STATE OF VERMONT AGENCY OF TRANSPORTATION

PROPOSED IMPROVEMENT BRIDGE PROJECT TOWN OF HARTLAND COUNTY OF WINDSOR

RECORD PLANS	
CONTRACTOR:	KUBRICKY CONSTRUCTION CORP. - WILTON, NY
RESIDENT ENGINEER:	DARYL BASSETT
CONSTRUCTION BEGAN:	JUNE 10, 2014
CONSTRUCTION COMPLETE:	NOVEMBER 5, 2014
RECORD PLANS BY:	DARYL BASSETT & KEVIN KING
I HEREBY CERTIFY THAT ALL THE CONSTRUCTION REQUIRED BY THIS SET OF DRAWINGS HAS BEEN ACCOMPLISHED AS INDICATED HEREIN.	
BY	RESIDENT ENGINEER
DATE	2/22/16
NOTE: Any further information concerning final quantities, amounts or other details relative to this project may be found by contacting Vtrans Records Management.

US ROUTE 5 (MAJOR COLLECTOR), BRIDGE NUMBERS 62A AND 66

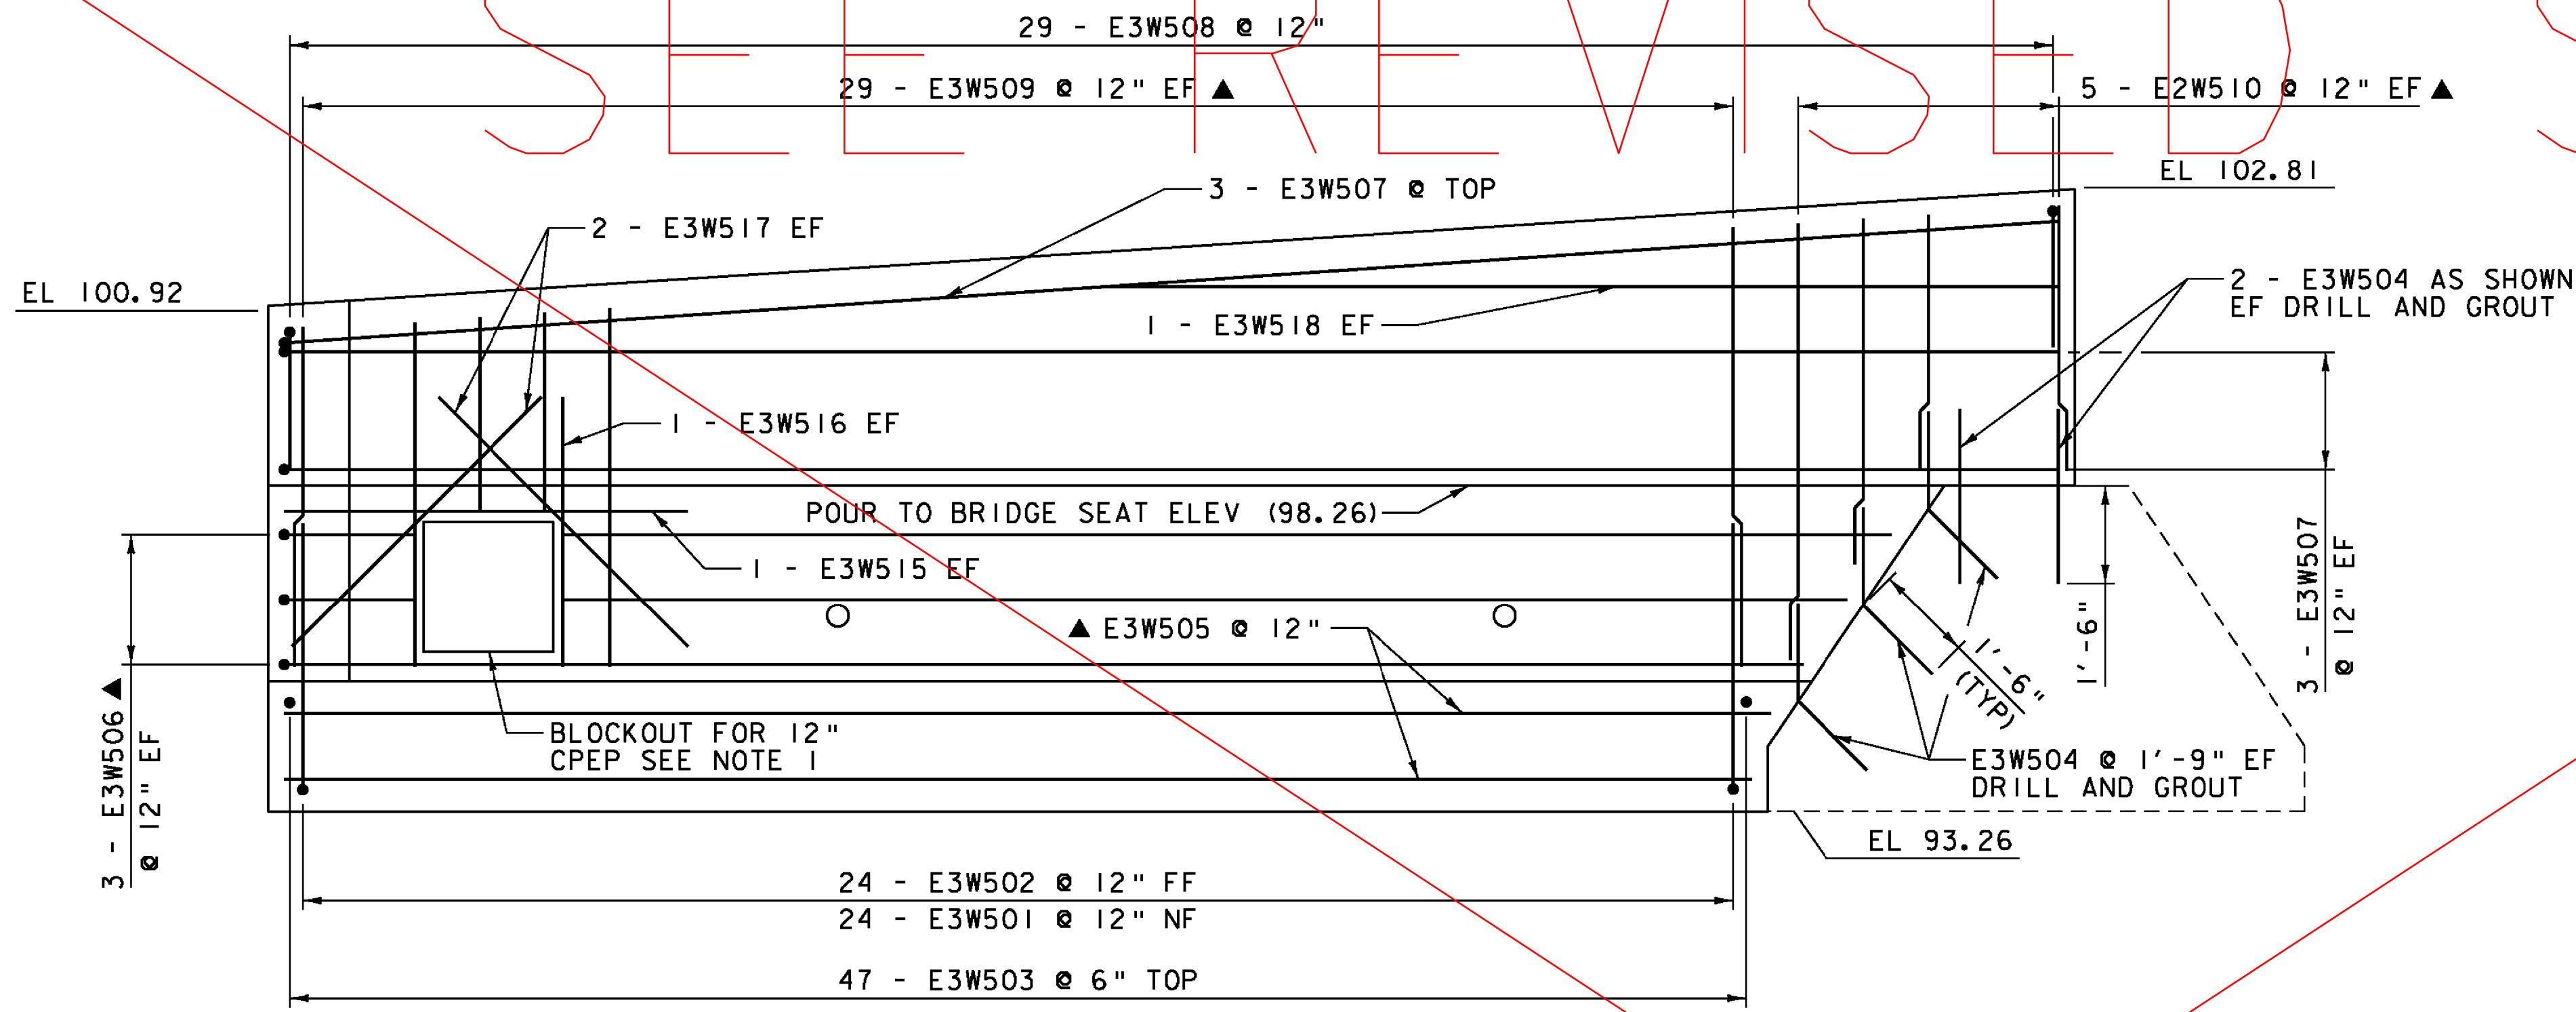
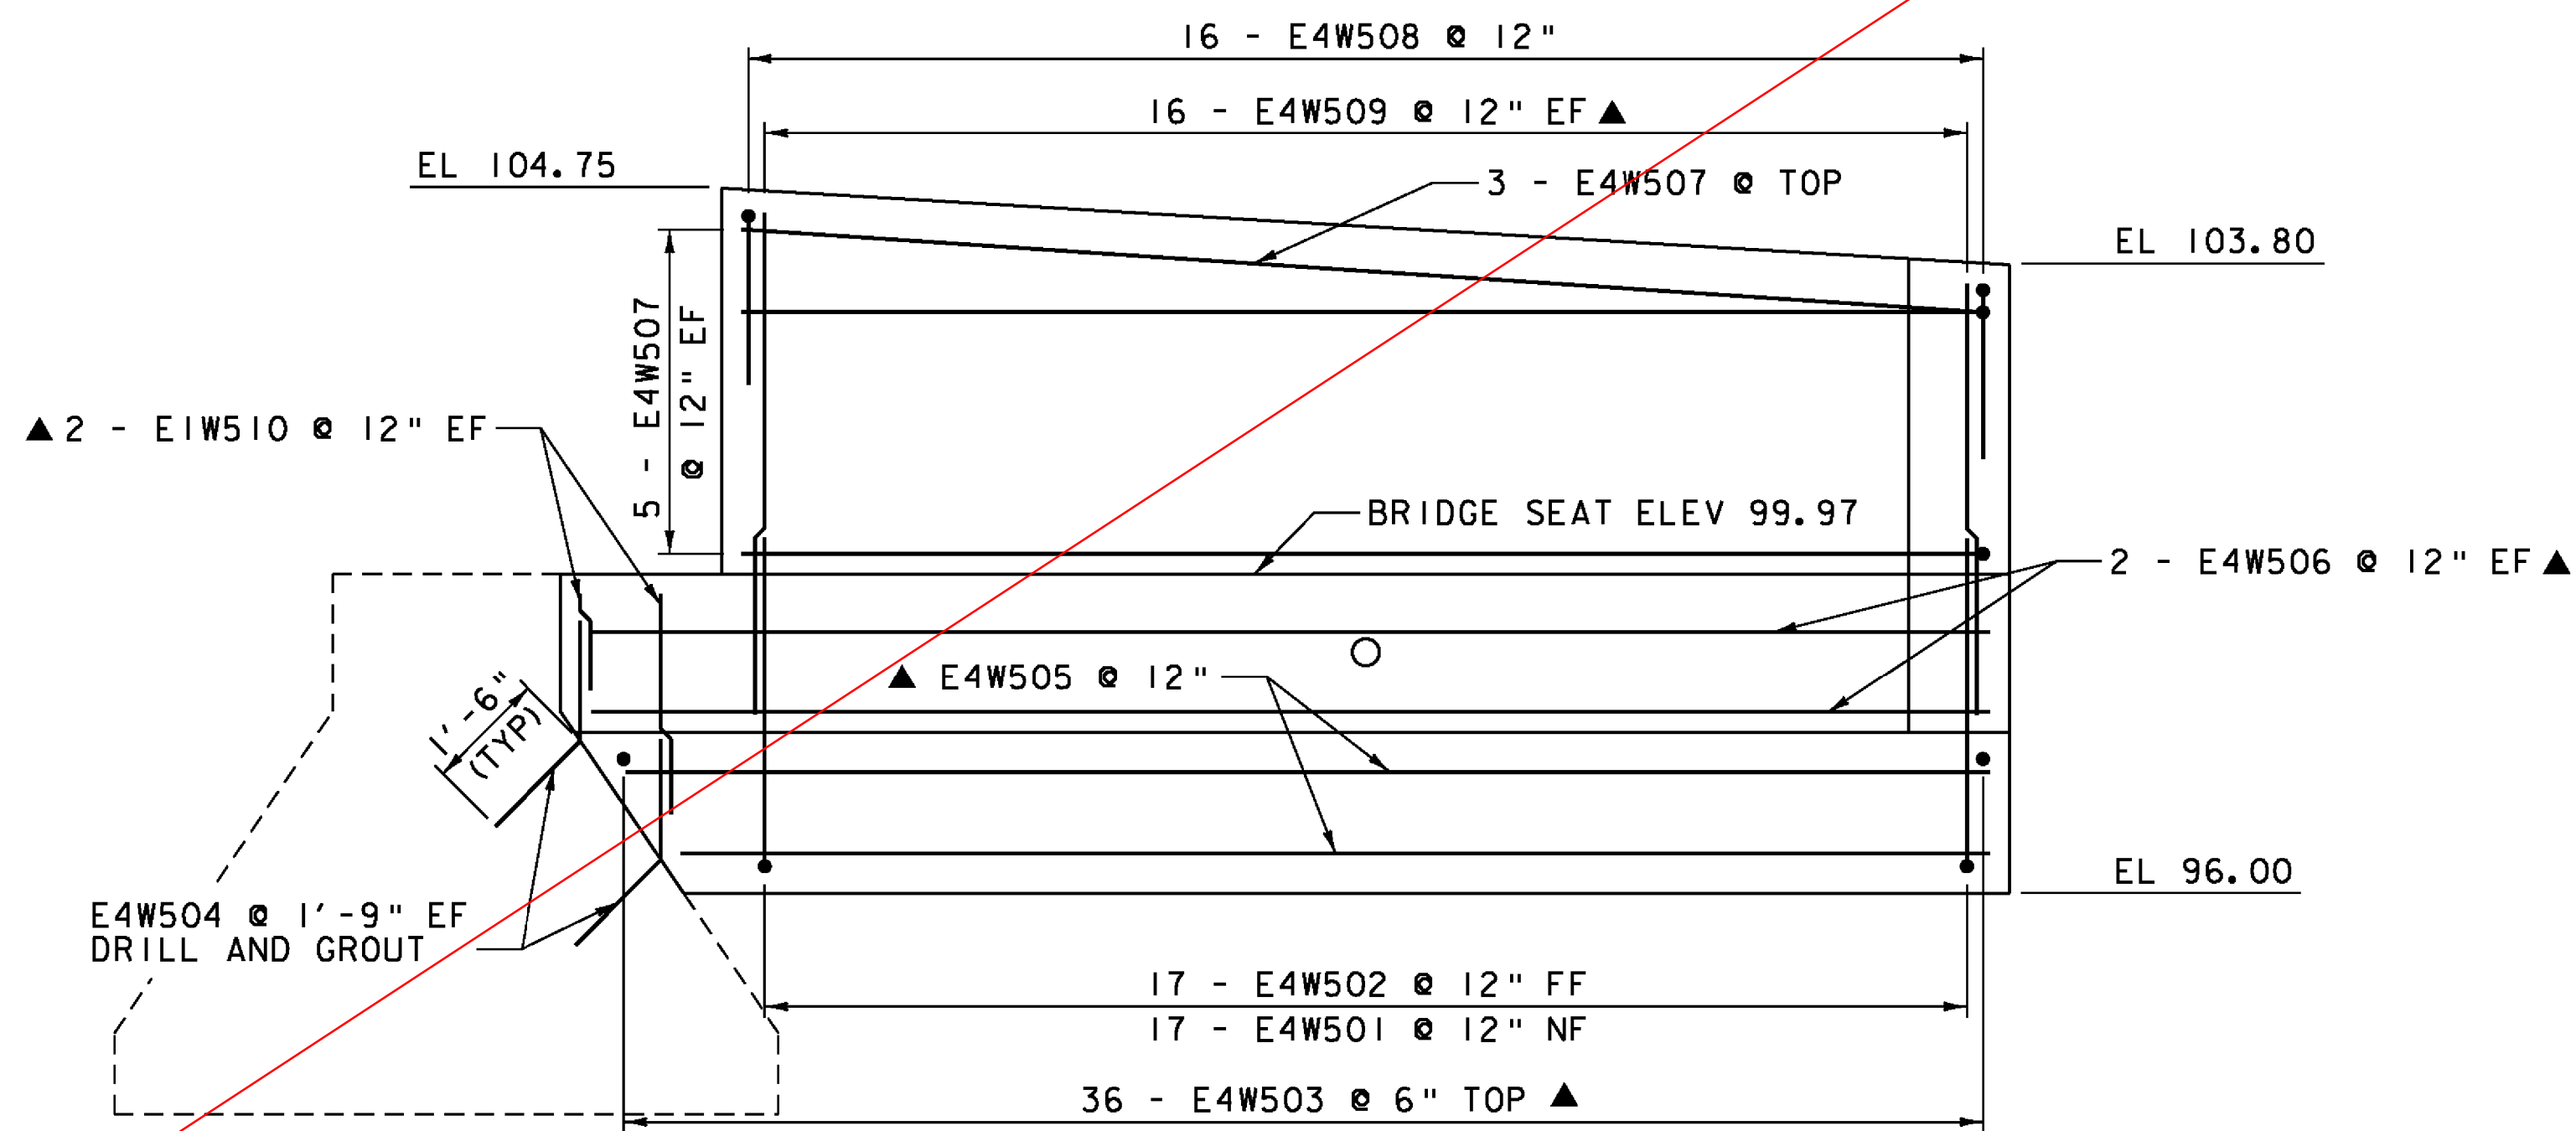
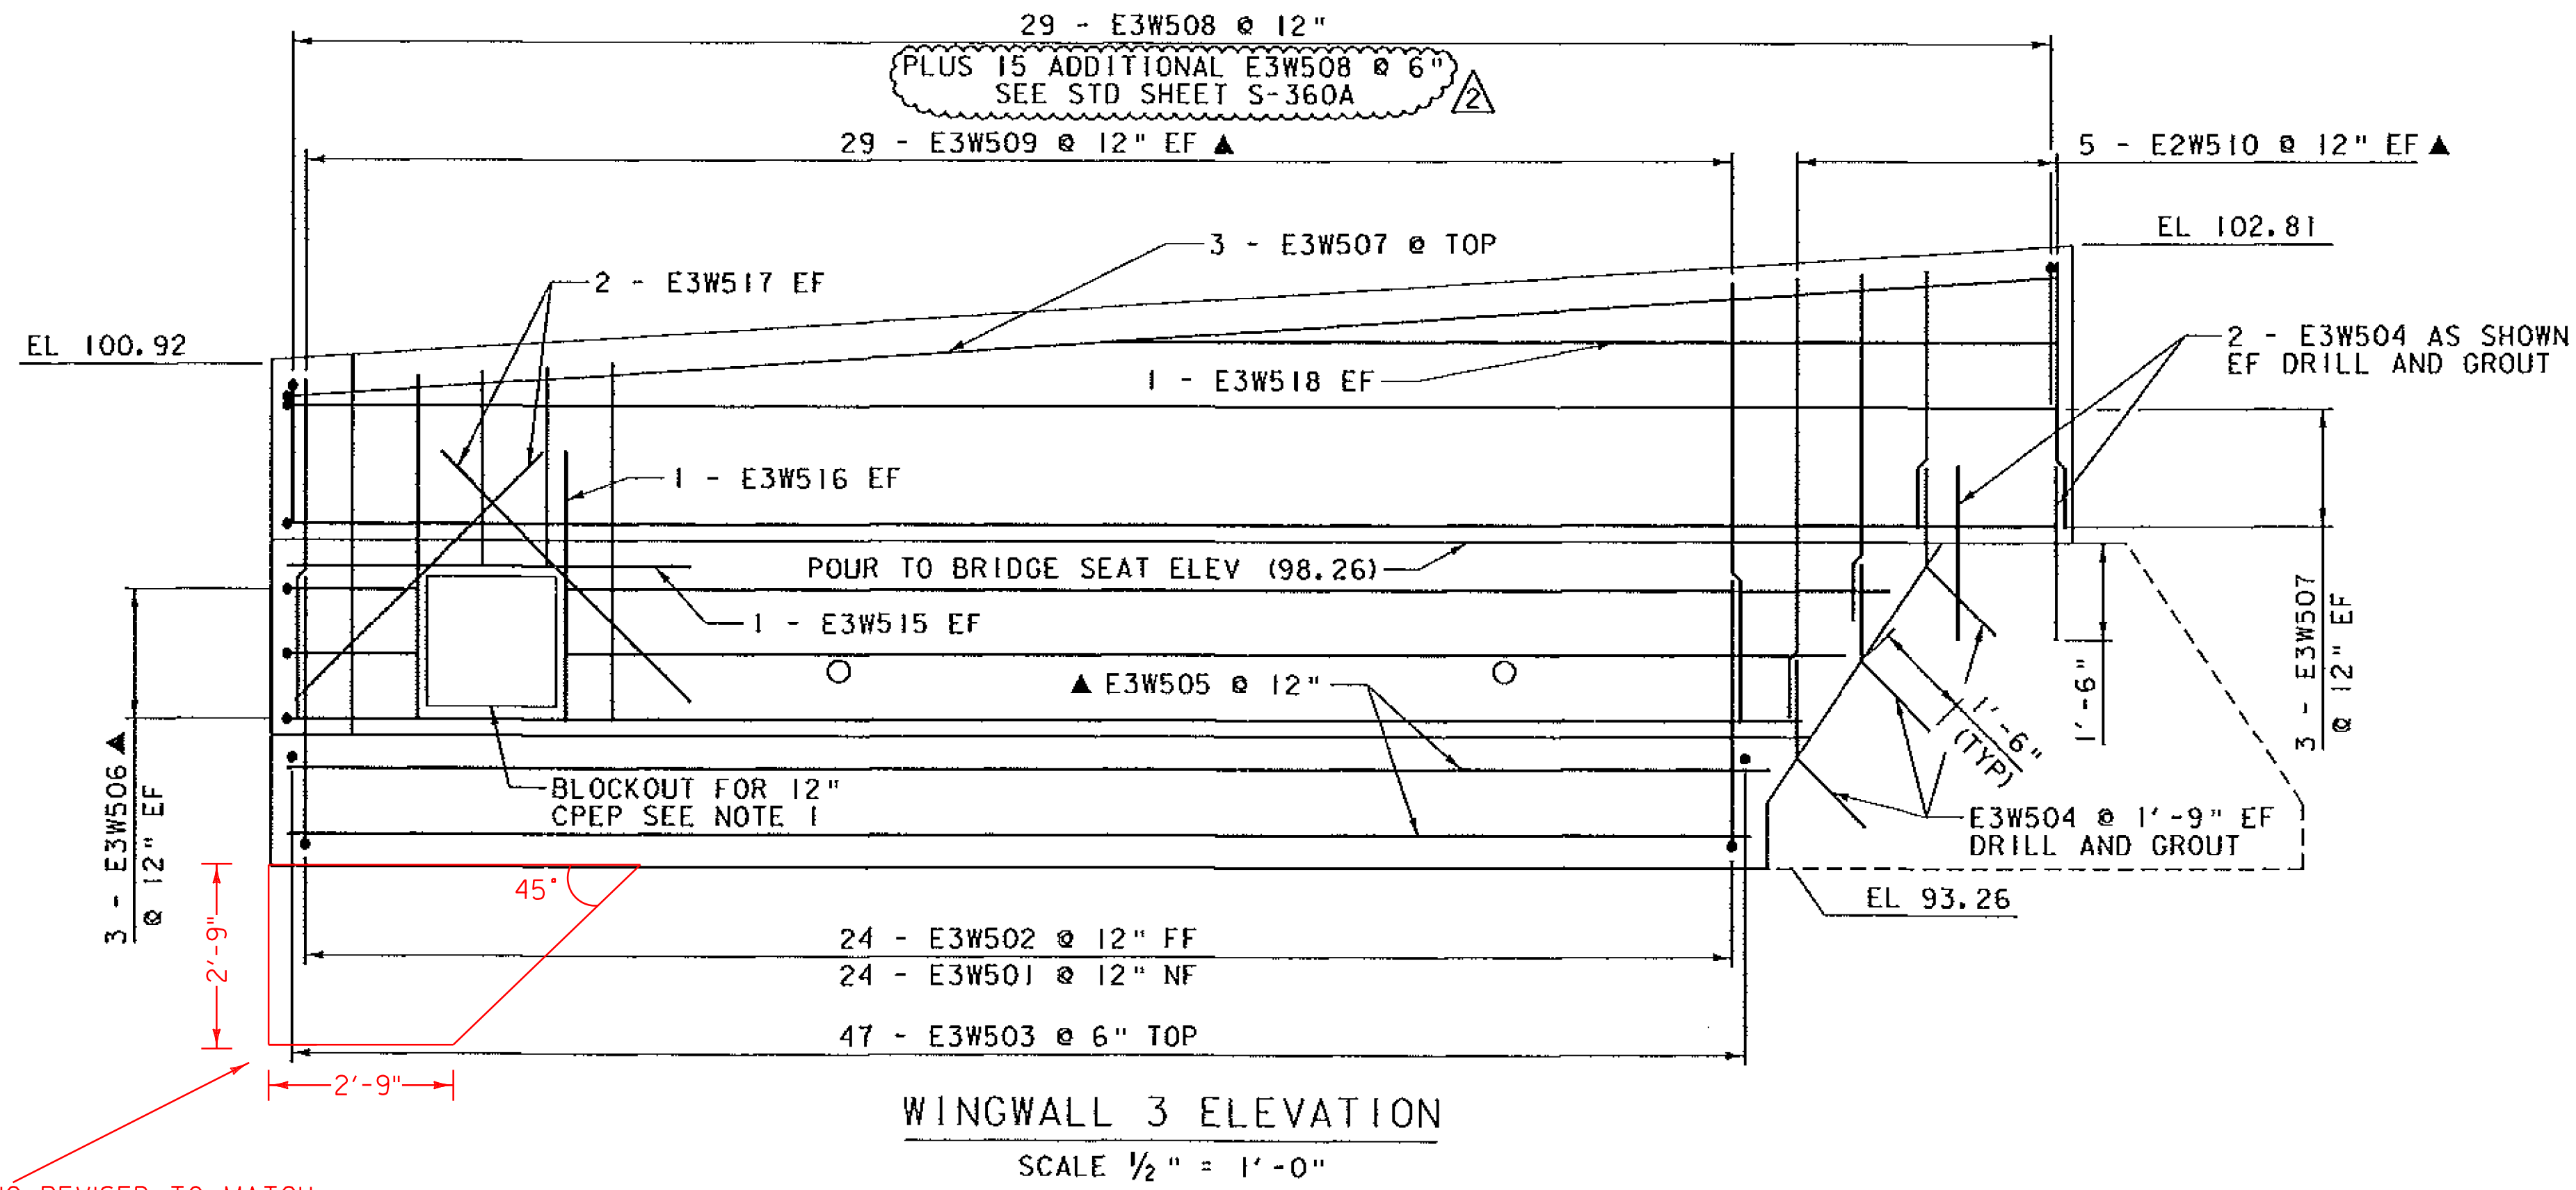
REV.	DESCRIPTION	DATE
△	ADDITIONAL EW508 AT POSTS	3/3/2014
PROJECT NAME: HARTLAND		
PROJECT NUMBER: BHF BPNT(12)		
FILE NAME: zllc260sub.dgn		PLOT DATE: 3/3/2014
PROJECT LEADER: M.A. COLGAN		DRAWN BY: A.J. GOUDREAU
DESIGNED BY: A.J. GOUDREAU		CHECKED BY: S.G. FARNSWORTH
BR 62A WINGWALL DETAILS (2 OF 2)		SHEET 29 OF 55
